Access Compliance Report

Public Rights-of-Way

(Pedestrian Signals)

Intersection ID: N/A	Main Street:	Cross Street: N/A	Location: N/A
ADA ID: A1B3975D475E	Signal Type: Two Push Buttons-Non APS	Overall Compliance: No	Severity Score: BTN 1:N/A BTN 2: N/A No BTN: N/A
Codes/Mitigation Info/Possible Solution		Field Measurements/Component Compliance

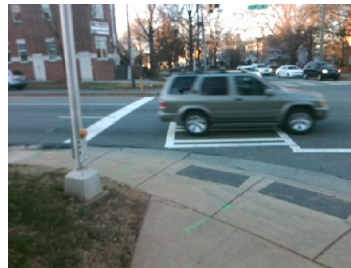
PROW/ADA: TMUTCD 4e.08, R404.2, R406.2, R404.7.3

Possible Solutions: Replace Signal Push Button With APS Button on New Post. Remove & Relocate Sign.
